# Port Master Plan Update
# Revised Draft PMPU Comments

***Comments received during the four-week public review period:***

**October 20, 2020 – November 17, 2020**

# Revised Draft PMPU Comments

FIGURE PD1.4 SHELTER ISLAND PLANNING DISTRICT - COASTAL ACCESS: VIEWS AND PATHWAYS

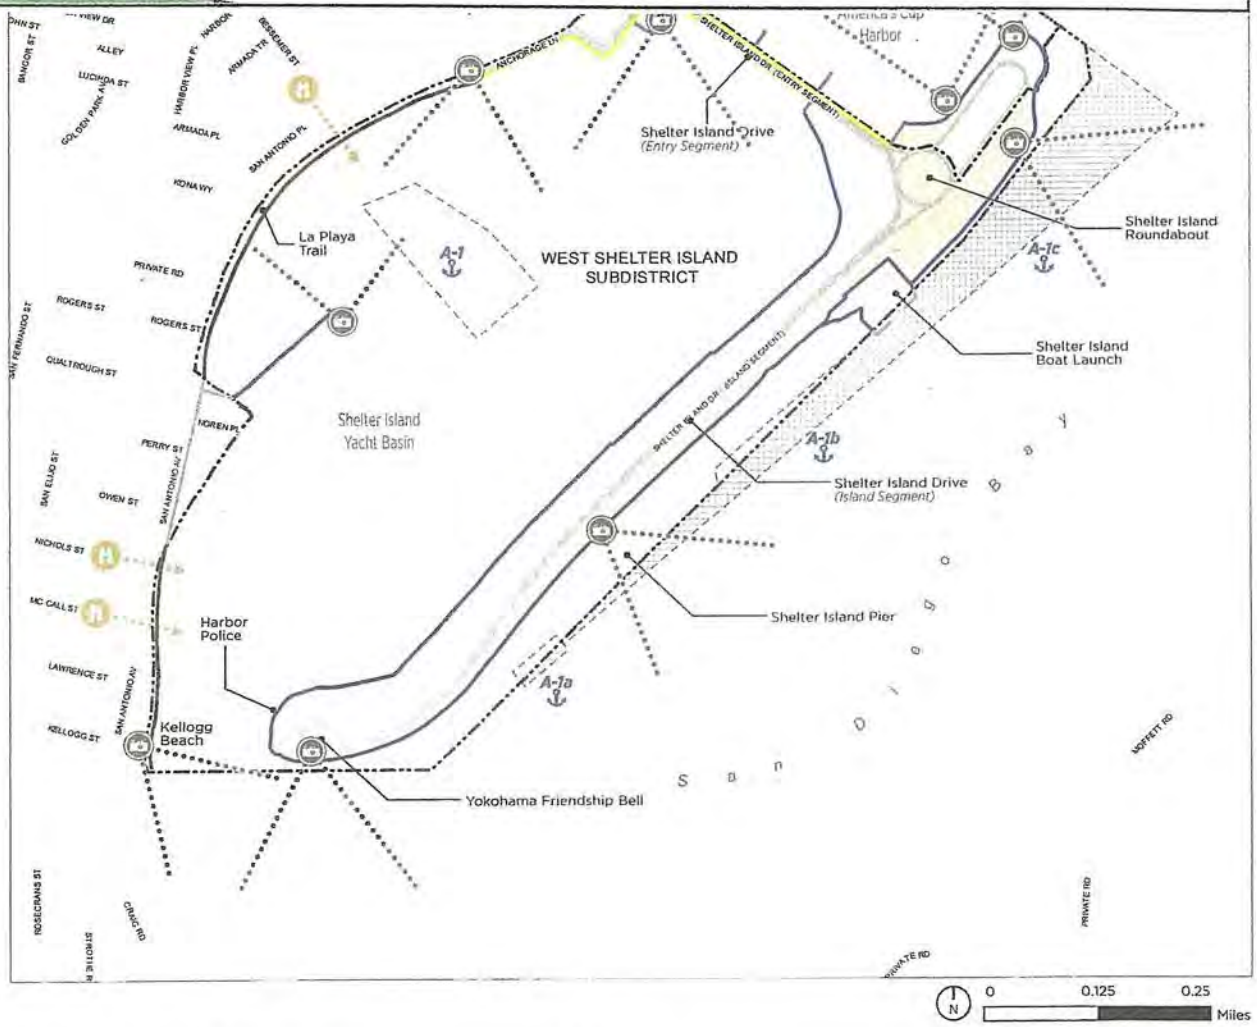
For purposes of clarification, in **Exhibit 1**, superimposed on Figure PD1.4 is the Example Clarification, (published by the Port in its Presentation and Direction to Staff on September 15, 2019), marked up in white pen, showing the current approaches to the launch ramp. The lower half of the page is the proposed Pathways map. As it pertains to the promenade/bike path, the difference between the two maps is the color of the current waterside promenade. Formerly purple, now blue.

As presented by the San Diego Port District in the Revised Draft of the Port Master Plan Update, the map on PD1.4 indicates that the proposed promenade will intersect and interfere with the operations of the Shelter Island Boat Launch Ramp Facility.

industry and the opportunity to provide an enjoyable boating experience, the Outboard Boating Club requests that the promenade/bike path continue in a straight line from the Bali Hai past the Shelter Island Launch Ramp Facility. The Boating Club requests that the current configuration of the Promenade/bike path be deleted as depicted in **Exhibit 4.** The Outboard Club further requests that additional parking be provided for cars/trailers in the Shelter Island Launch Ramp Facility.

# PD 01 **SHELTER ISLAND**

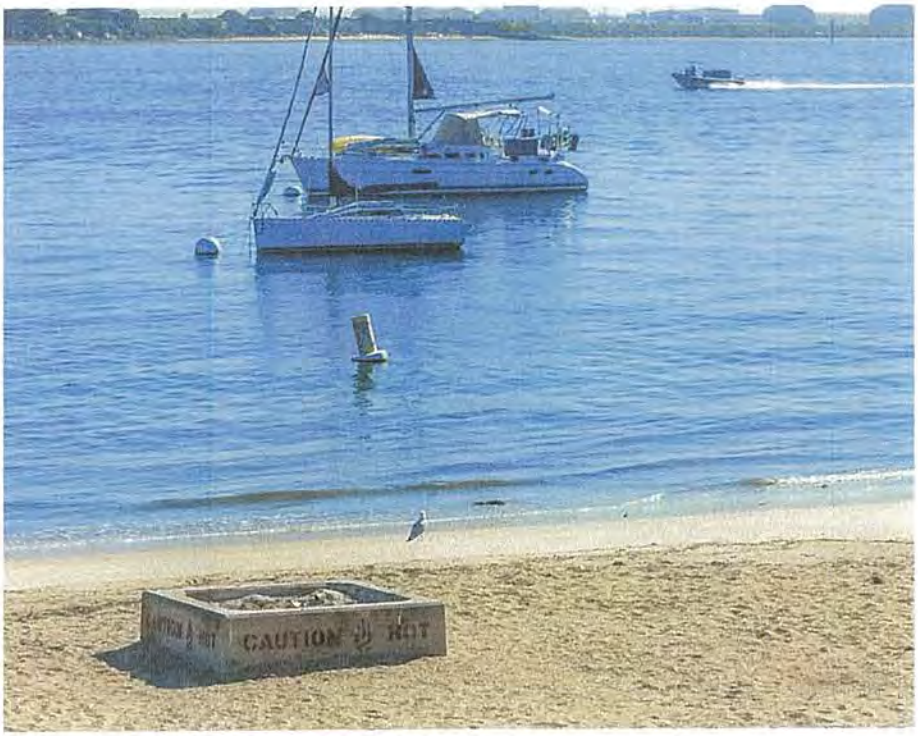
The proposed Shelter Island Boat Launch Ramp and Promenade/Bike Path is described in PD 01 SHELTER ISLAND: "The addition of a promenade and bike path remain in the Revised Draft PMPU. The waterside promenade and bike path will go behind the ***ship chandlery*** [emphasis added] * near the Shelter Island Boat Launch. Parking will be available to the general public with limited exceptions." Please see **Exhibit 2.**

There is no ship chandlery near the Shelter Island Boat Launch. The Revised Port Master Plan erroneously describes the Outboard Boating Club Observation Building as a ***ship chandlery*** [emphasis added]. **Exhibit 2** This error needs to be corrected in the final Port Master Plan. A better description might be the Outboard Boating Club Observation Building.

FIGURE PD1.4 SHELTER ISLAND PLANNING DISTRICT - COASTAL ACCESS: VIEWS AND PATHWAYS

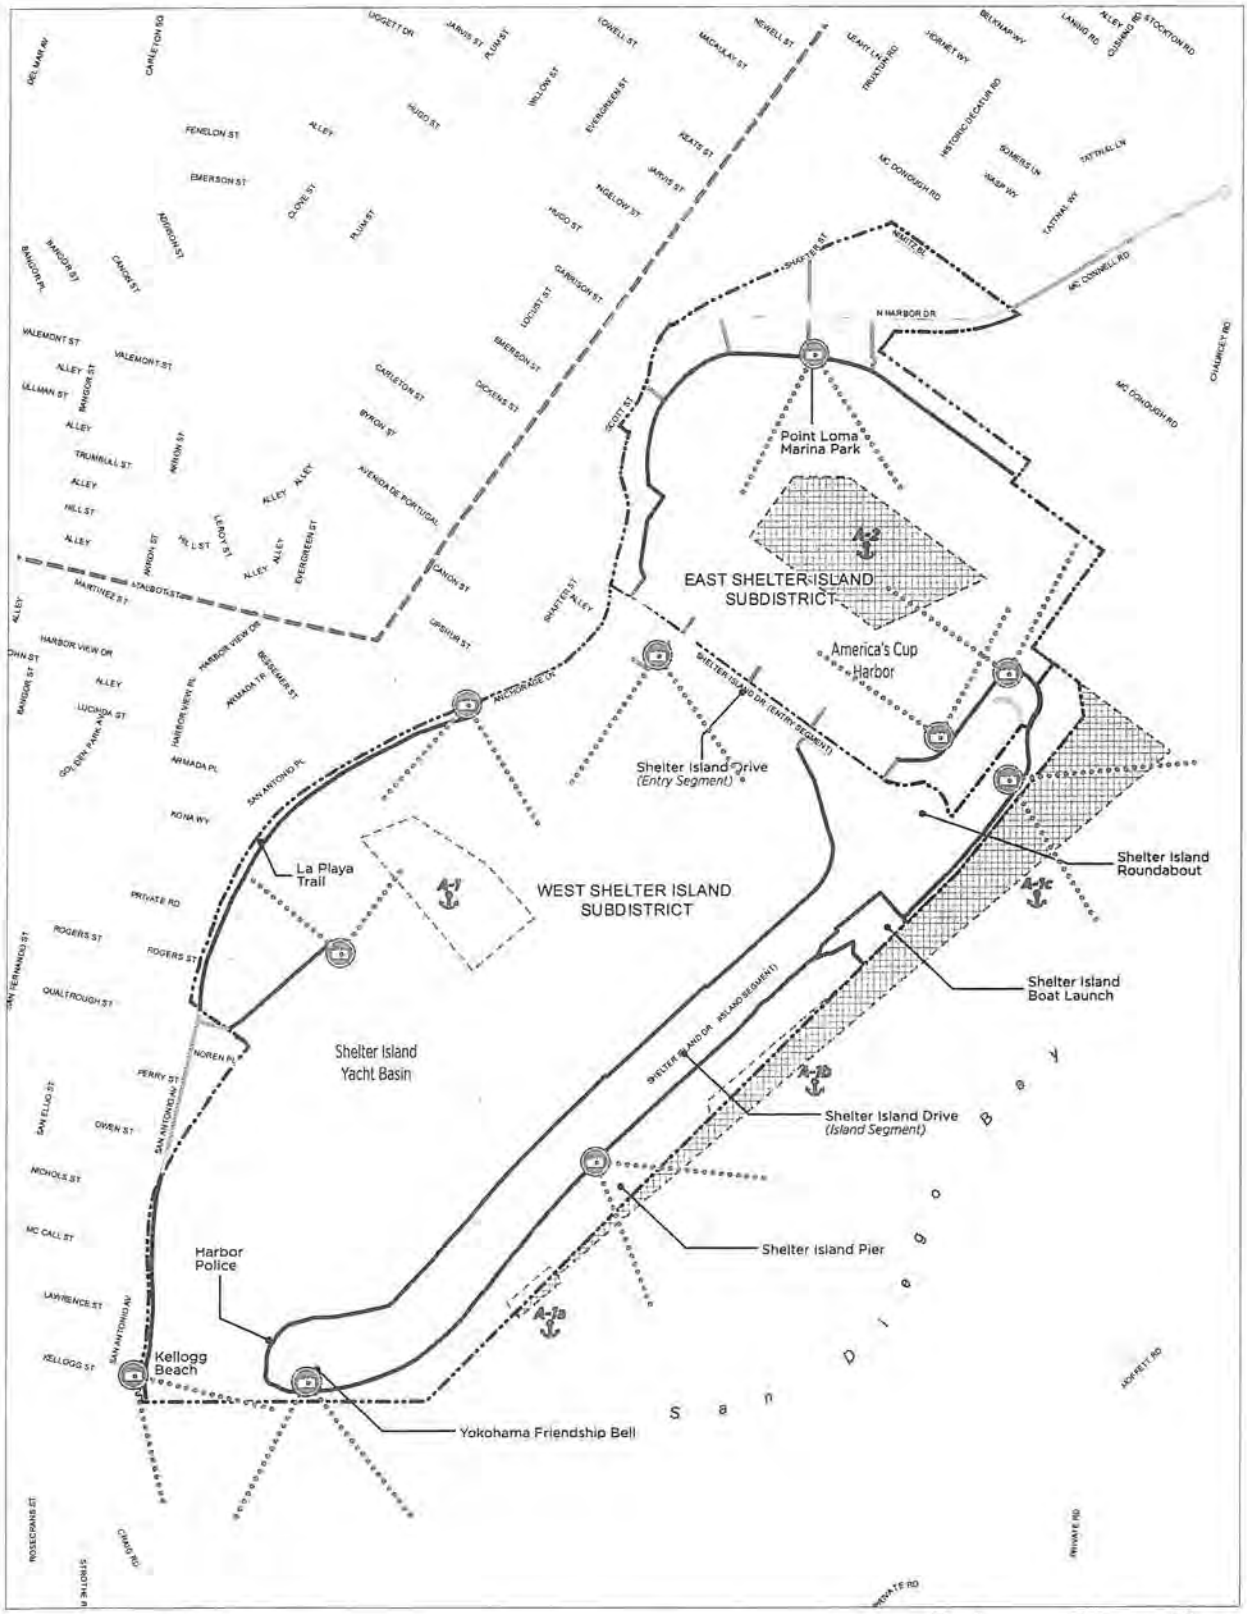
If the current plan is accepted to route the promenade/bike path behind the Outboard Boating Club Observation Building, 6 car/trailer parking spaces would be eliminated. An alternative configuration would be to exchange the car/trailer parking for general parking and convert 6 general parking spaces to car/trailer paring in the Launch Ramp Facility. To create a waterside promenade/bike path through the Shelter Island Boat Launch Facility Lower Parking Lot (as shown in Exhibit 1, PD1.4), would eliminate countless additional car/trailer parking spaces.
